# Town of Hilton Head Island Regular Design Review Board Meeting

Tuesday, June 12, 2012

**Town of Hilton Head Island**  
**Design Review Board**  
**Minutes of the Tuesday, March 27, 2012 Meeting**     **DRAFT**  
**1:15p.m – Benjamin M. Racusin Council Chambers**

**Town of Hilton Head Island**  
**Design Review Board**  
**Minutes of the Tuesday, May 22, 2012 Meeting**      **DRAFT**  
**1:15p.m – Benjamin M. Racusin Council Chambers**

<b>Sheet Title:</b>	SITE ANALYSIS
<b>Job Number:</b>	201203-01
<b>Date:</b>	May 18, 2012
<b>Drawn:</b>	MY
<b>Approved:</b>	CD
<b>Revisions:</b>

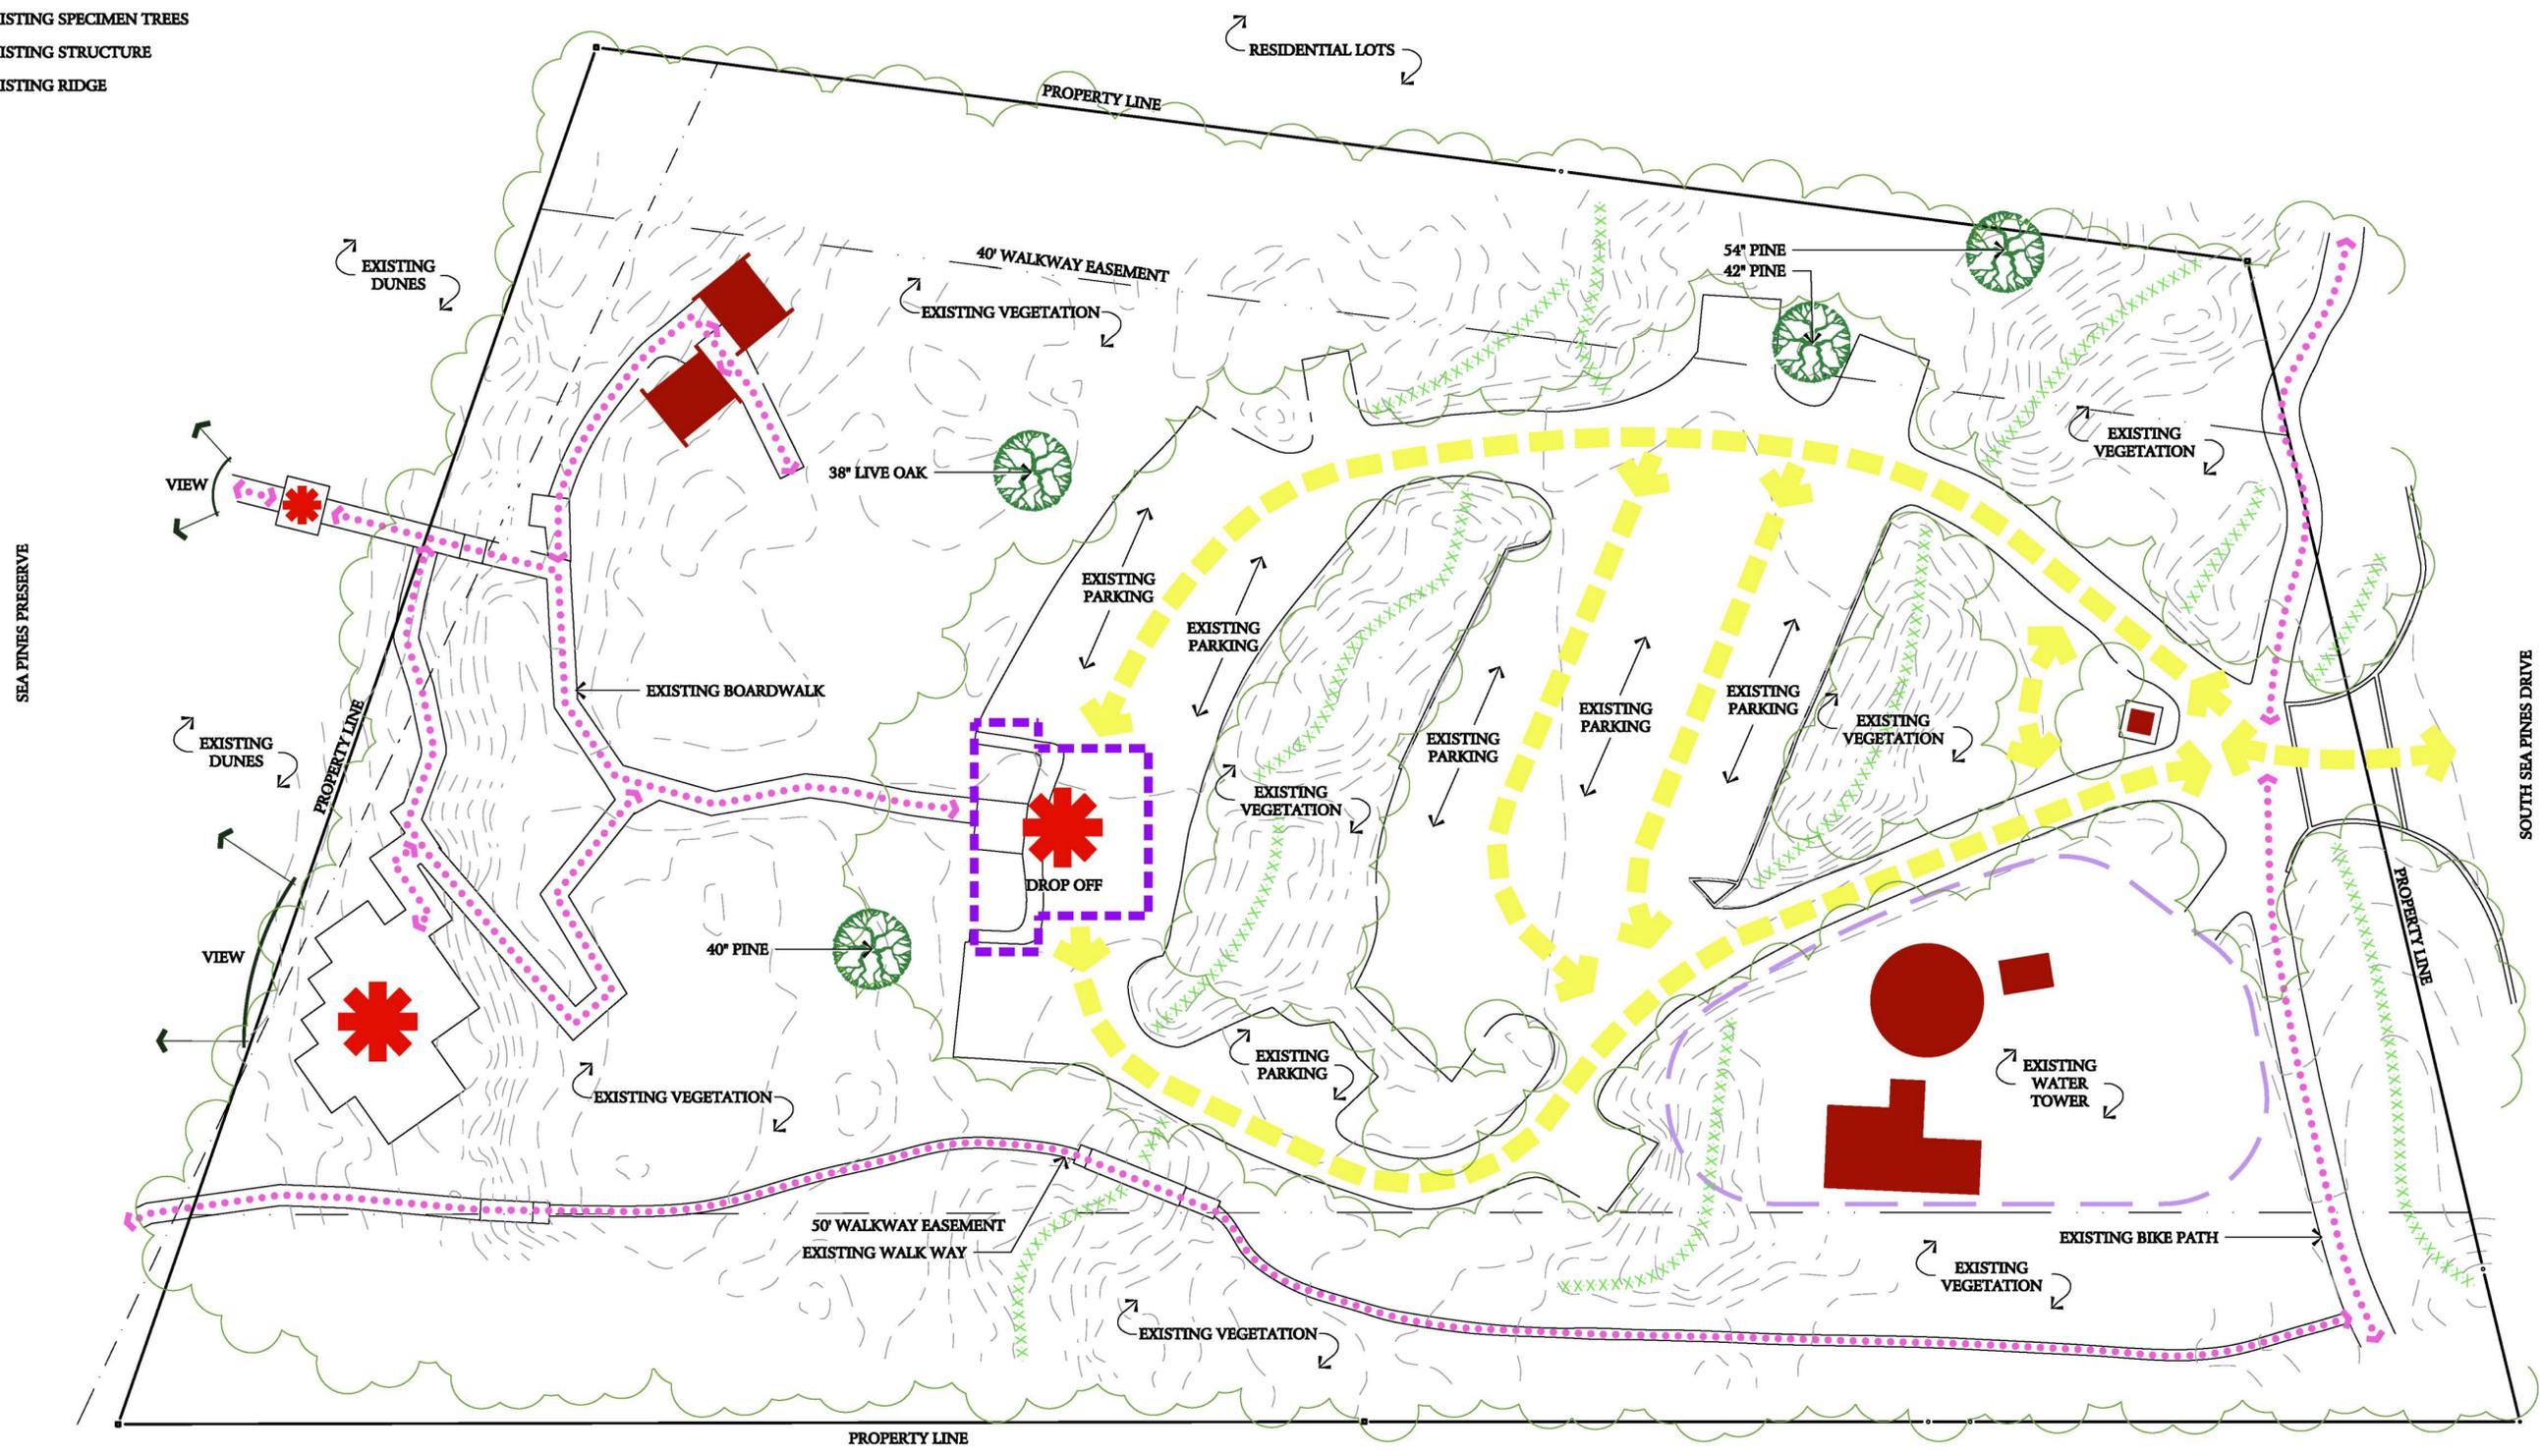
Design is appropriate for its use	<input checked="" type="checkbox"/>	<input type="checkbox"/>	<input type="checkbox"/>	
All facades are have equal design characteristics	<input checked="" type="checkbox"/>	<input type="checkbox"/>	<input type="checkbox"/>	
Avoids monotonous planes or unrelieved repetition	<input checked="" type="checkbox"/>	<input type="checkbox"/>	<input type="checkbox"/>	
Has a strong roof form with enough variety to provide visual interest	<input checked="" type="checkbox"/>	<input type="checkbox"/>	<input type="checkbox"/>	
Minimum roof pitch of 6/12	<input checked="" type="checkbox"/>	<input type="checkbox"/>	<input type="checkbox"/>	
Overhangs are sufficient for the façade height.	<input checked="" type="checkbox"/>	<input type="checkbox"/>	<input type="checkbox"/>	Security Station features an aggressive

<b><i>NATURAL RESOURCE PROTECTION</i></b>				
<b>DESIGN GUIDE/LMO CRITERIA</b>	<b>Complies Yes</b>	<b>No</b>	<b>Not Applicable</b>	<b>Comments or Conditions</b>
An effort has been made to preserve existing trees and under story plants	<input checked="" type="checkbox"/>	<input type="checkbox"/>	<input type="checkbox"/>	
Supplemental and replacement trees meet LMO requirements for size, species and number	<input type="checkbox"/>	<input type="checkbox"/>	<input checked="" type="checkbox"/>	
Wetlands if present are avoided and the required buffers are maintained	<input type="checkbox"/>	<input type="checkbox"/>	<input type="checkbox"/>	Applicant will need to verify with Community Development with a formal site plan, and topography information

Sand dunes if present are not disturbed	<input type="checkbox"/>	<input type="checkbox"/>	<input type="checkbox"/>	Applicant will need to verify with Community Development that the proposed elements do not violate the Town's Dune Accretion criteria with a formal site plan, and topography information
---	--------------------------	--------------------------	--------------------------	---

<p>Application is also under Conceptual Review by the Sea Pines ARB, but is being reviewed concurrently to expedite permitting. The Town cannot and will not give final approval for the project until it is in receipt of Final Approval from the Sea Pines ARB.</p> <p>Board will need to see a detail for the arbor/ pergola structures on the beachfront.</p>

A SELECTION CENTER AND OFFICES FOR:  
**BUILDING INNOVATIONS, LLC**  
LOT 20 NEW ORLEANS ROAD  
SHIPYARD PLANTATION COMMERCIAL  
HILTON HEAD IS., SC  
BEAUFORT COUNTY DIST. 541, MAP 15C, PAR. 69

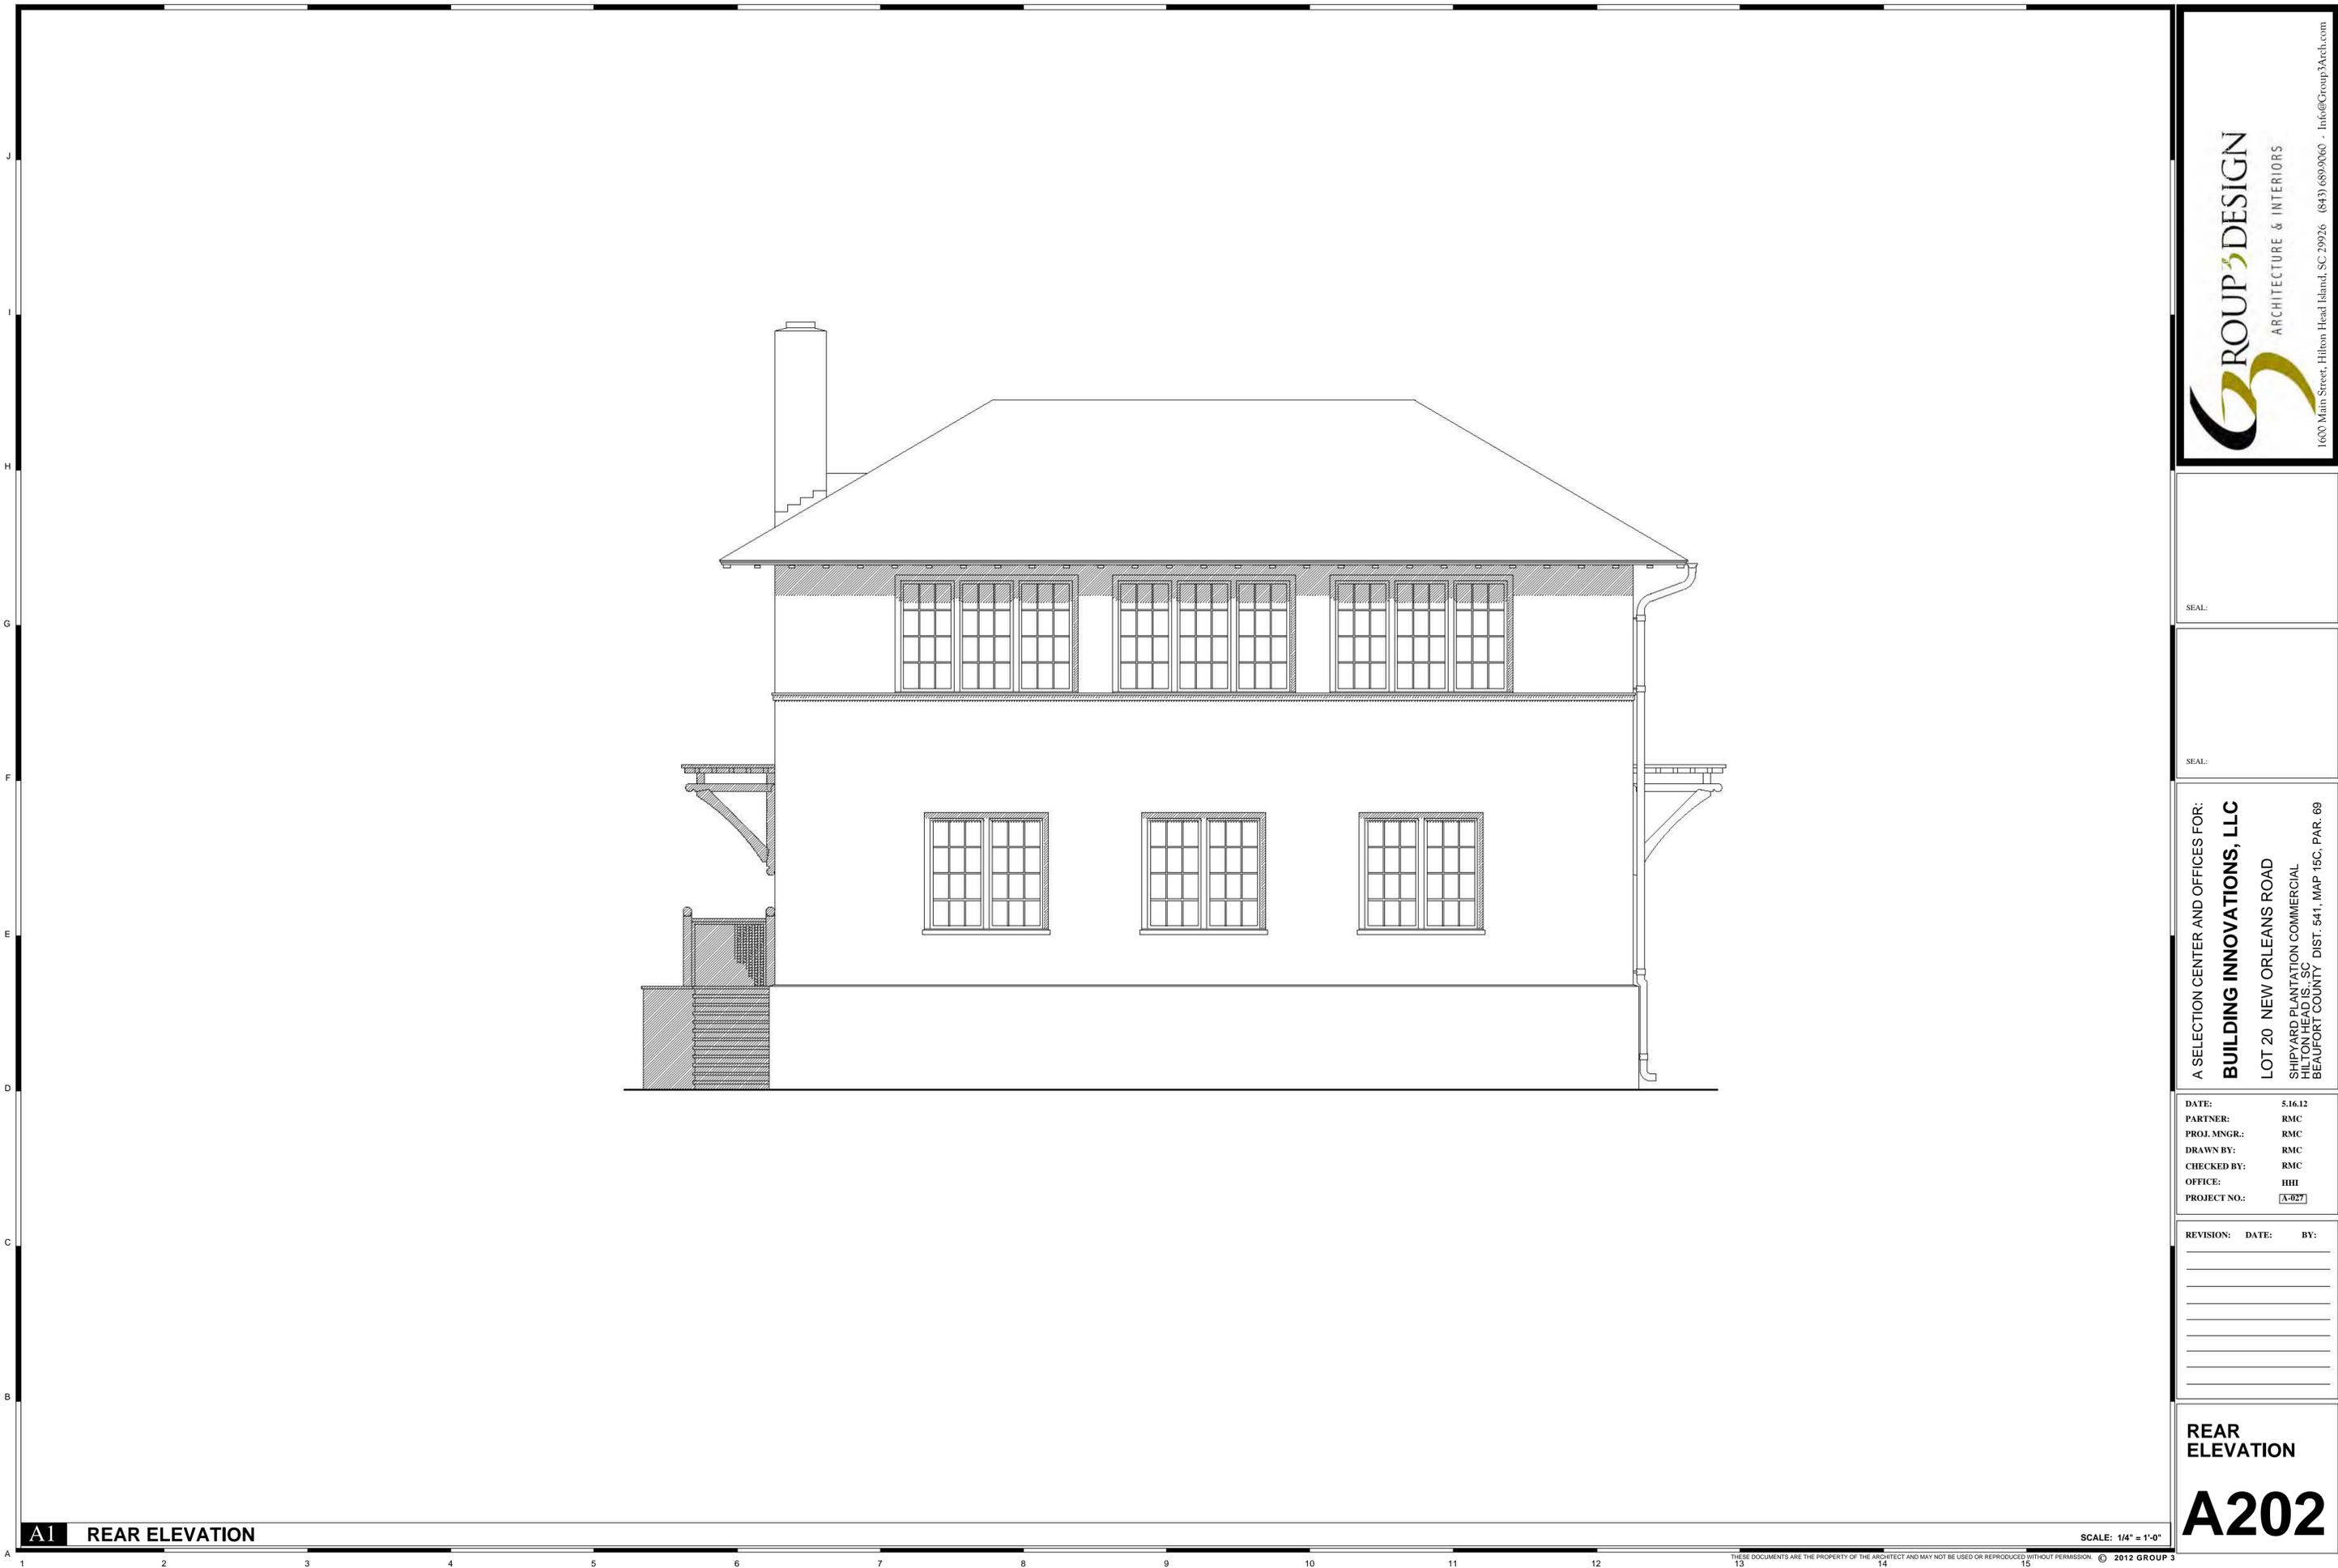
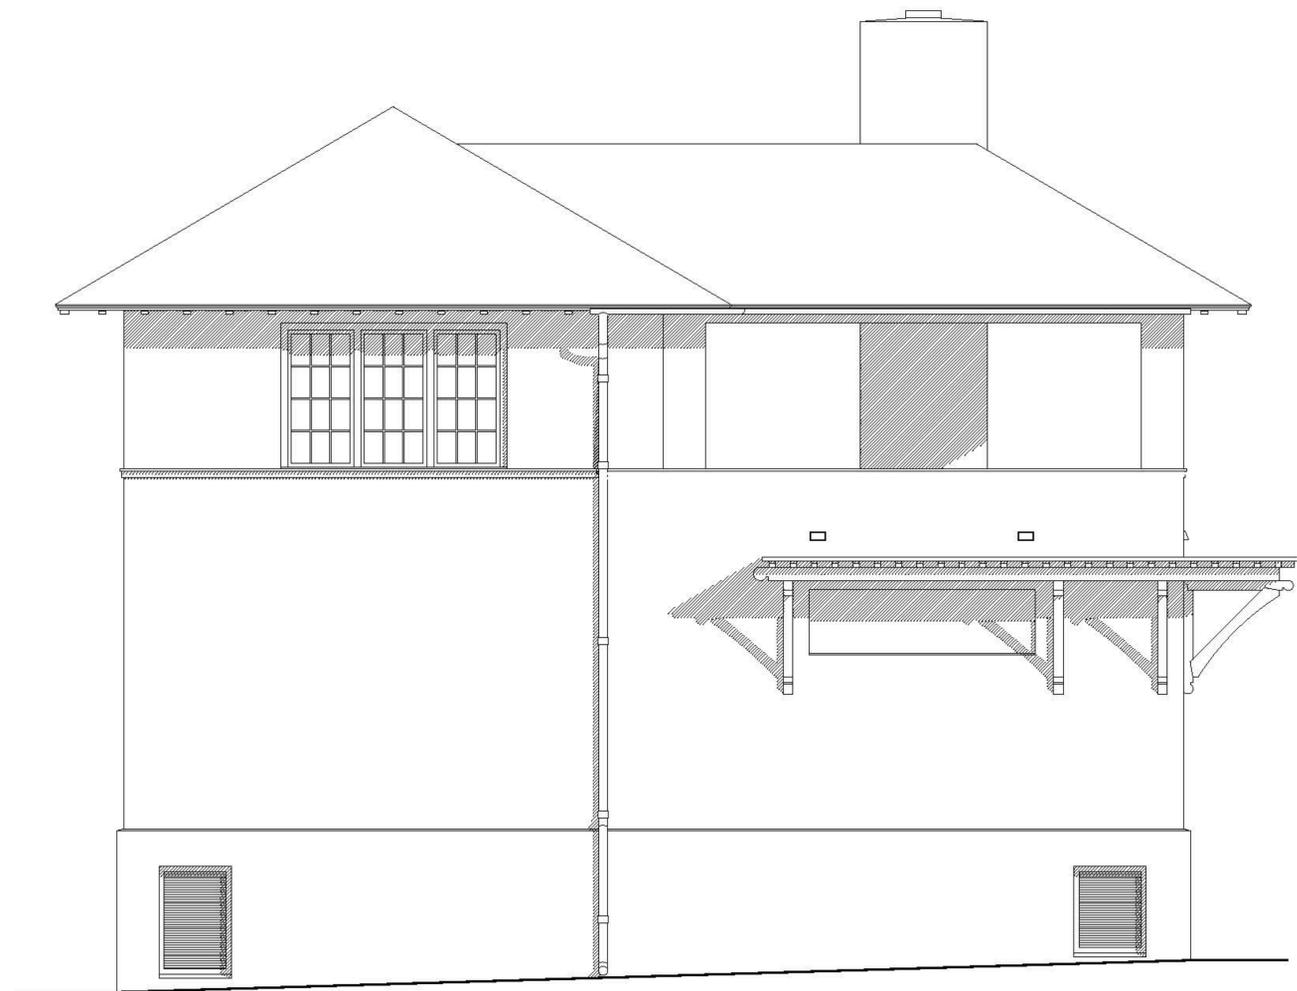
All facades are have equal design characteristics	<input type="checkbox"/>	<input checked="" type="checkbox"/>	<input type="checkbox"/>	Left and Right elevations might benefit from more of the roof form, at least over the door on the right side. Back-of-the house recognizes WHP, and doesn't have to obscure HVAC units
Avoids monotonous planes or unrelieved repetition	<input checked="" type="checkbox"/>	<input type="checkbox"/>	<input type="checkbox"/>	
Has a strong roof form with enough variety to provide visual interest	<input checked="" type="checkbox"/>	<input type="checkbox"/>	<input type="checkbox"/>	
Minimum roof pitch of 6/12	<input checked="" type="checkbox"/>	<input type="checkbox"/>	<input type="checkbox"/>
